BURNS AND ROE, INC. WPPSS NUCLEAR PROJECT NO. 2	PROJECT ENGINEERING DIRECTIVE	<table border="1" style="width:100%; border-collapse: collapse;"> <tr> <td style="width:5%;">CODE</td> <td colspan="15">PROJECT ENGINEERING DIRECTIVE</td> </tr> <tr> <td>2</td><td>1</td><td colspan="13"></td><td>2</td><td>1</td><td>5</td><td>-</td><td>C</td><td>5</td><td>-</td><td>2</td><td>7</td><td>4</td><td>1</td> </tr> <tr> <td>1</td><td>2</td><td>3</td><td>4</td><td>5</td><td>6</td><td>7</td><td>8</td><td>9</td><td>10</td><td>11</td><td>12</td><td>13</td><td>14</td><td>15</td> <td colspan="2">DATE</td> <td>0</td><td>3</td><td>/</td><td>1</td><td>3</td><td>/</td><td>8</td><td>0</td> <td colspan="2">PRIORITY</td> <td colspan="2">II</td> </tr> <tr> <td colspan="2"><input checked="" type="checkbox"/></td><td>16</td><td>17</td><td colspan="2"><input checked="" type="checkbox"/></td><td>18</td><td>19</td><td colspan="2"><input checked="" type="checkbox"/></td><td>20</td><td>21</td><td colspan="4"></td> </tr> </table>	CODE	PROJECT ENGINEERING DIRECTIVE															2	1														2	1	5	-	C	5	-	2	7	4	1	1	2	3	4	5	6	7	8	9	10	11	12	13	14	15	DATE		0	3	/	1	3	/	8	0	PRIORITY		II		<input checked="" type="checkbox

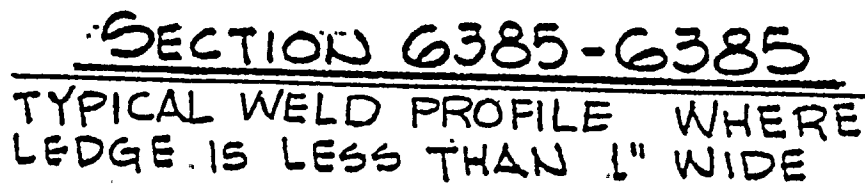
ENG. SYSTEM	N/A																																																																																								
S/U SYSTEM																																																																																									
QUALITY CLASS	I																																																																																								
ORIGINATING DOCUMENTS <u>NCR 215-5688</u>																																																																																									
DESCRIPTION OF WORK: <div style="font-size: 1.2em; font-family: cursive;"> REPLACE SLOT WELDS WITH A PARTIAL PENETRATION WELD BETWEEN THE UPPER AND LOWER RINGS AS DETAILED ON SHEETS 3 THRU 5 OF THIS P.E.D. WELD PREPARATION SHALL BE AS DIRECTED ON P.E.D. 215-W-2742. WELD QUALIFICATION SHALL BE AS DIRECTED ON P.E.D. 215-W-2749. REPAIR OF GAPS AT SHIMS (NCR 215-4884) SHALL BE AS DIRECTED ON PED 215-M-2746. WELD SHALL BE MADE AS DIRECTED ON P.E.D. 215-W-1604. </div>
